Re: Turkey Point Units 3 and 4
Docket Nos. 50-250 and 50-251
Request for Additional Information Regarding
Station Blackout Analysis (TAC Nos. MB8728 and MB8729)

**Response To NRC Request for Additional Information
Regarding Station Blackout Analysis for
Turkey Point Units 3 and 4**

FIGURE 1

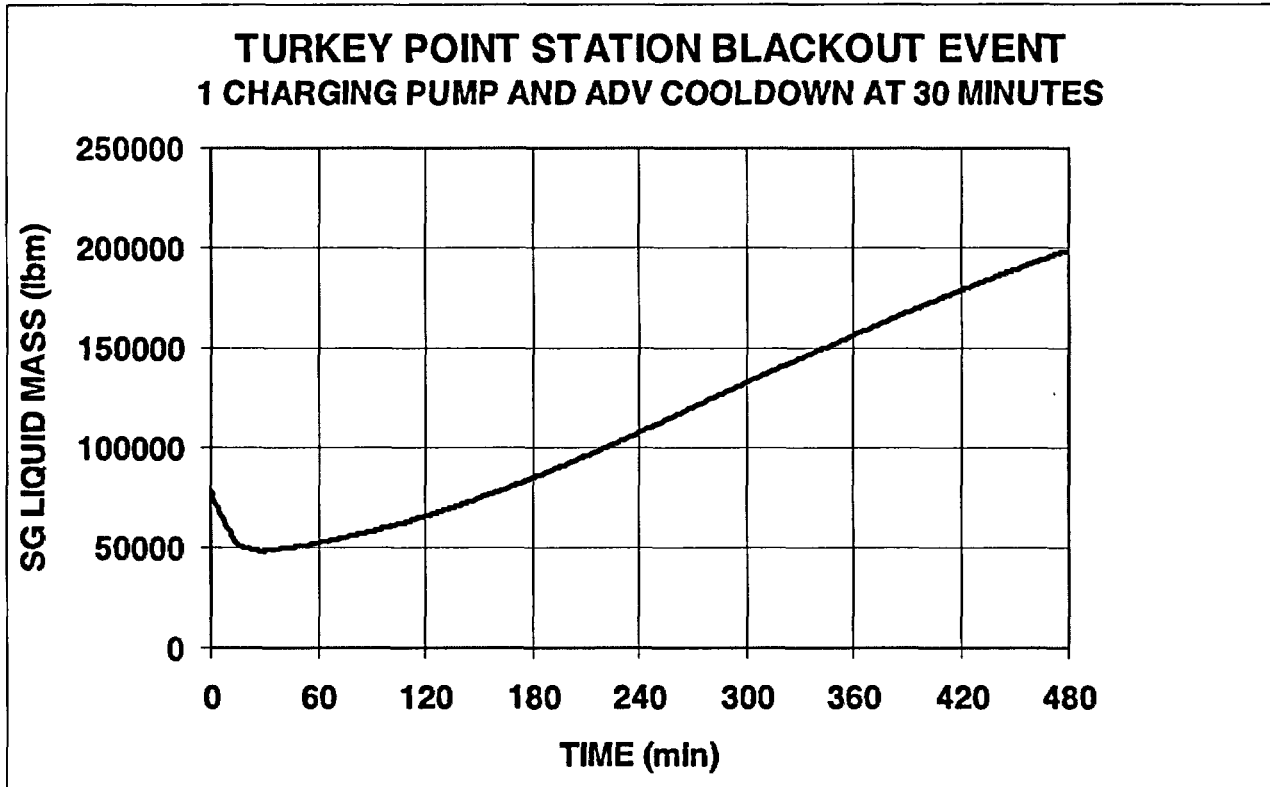
- A single volume is used for the upper head. Because an equilibrium model was employed, this region fills completely at 375 minutes, which does not appear to be correct. Once the SGs refill with liquid and single phase natural circulation is re-established, a bubble will remain in the upper head region (unless the RCPs are re-started or the head vent is used). Thus, following refill, the upper head will become superheated with wall heat transfer from the steam controlling the degree of steam superheat. The use of the single volume to represent the upper head and the equilibrium model will artificially condense the steam in this region, enabling a complete and early refill. Discuss whether a bubble in the upper head will significantly delay the ability to cool down the RCS to RHR entry conditions within the 8-hour period. A bubble in the upper head would cause the pressurizer level to decrease during charging pump operations. Given these considerations, discuss whether entry into shutdown cooling will be achieved before the condensate storage tank is exhausted. Discuss whether entry into shutdown cooling will be delayed if a fill-and-drain method is used and metal wall heat is taken into account. Include the capacity of the condensate storage tank and identify the time to exhaust this supply during the cooldown.*

Allowing phase separation in the region and modeling it as a non-equilibrium volume with metal heat from the vessel and structures would provide a more accurate response of the dynamics of the region. In particular, heat transfer from the metal to both the liquid and vapor phases would be predicted along with condensation of vapor onto the interface. This would have an effect on the depressurization rate and the time of refilling the region. However, given the fact that the heat sink is maintained through the continuous addition of auxiliary feedwater for the duration of the 8-hour event, this effect is not expected to challenge the overall conclusions of the analysis in terms of potential core uncover.

Given the relatively small RCS cooldown rate of 25 °F/hr, intended to prevent excessive upper head voiding, the homogeneous representation of the vessel upper head in the RETRAN model is considered appropriate for this application.

Aspects related to the capability to collapse the vessel upper head bubble, if still present at 8 hours when the shutdown cooling phase starts, are beyond the assumptions of the SBO analysis because at the end of the 8-hour period, the SBO event is assumed to terminate. The RETRAN analysis concluded that during the 8-hour SBO period, the aspects related to the dynamics of the upper head bubble will not interfere with the ability to maintain the core cooled, provided the heat sink is maintained, as demonstrated above.
